NOV_SCE_ATJ_20211130-01_Revised

NOTICE OF VIOLATION

Report Name: ATJ_SCE_20211130-01_Revised
Date(s) of Inspection: November 30, 2021
Inspector: Anthony Trujillo
Utility: Southern California Edison
Attention: Erik Takayesu, Vice President Asset Strategy and Planning

Structure ID: 463639E

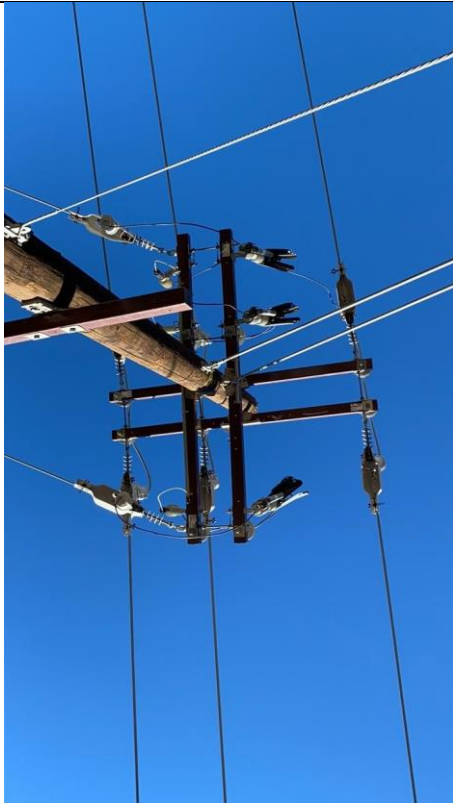
Item1IA1mg1: Vibration dampers not installed

Item1IA1mg2: Close up, no vibration dampers installed

Structure ID: 4944416E

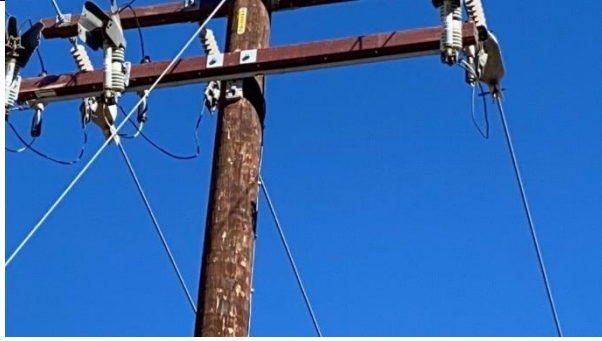
Item13IA1mg1: Bare wire to covered conductor

Item13IA1mg2: Bare wire to covered conductor close up

Item13IA3Img1: Vibration dampers not installed
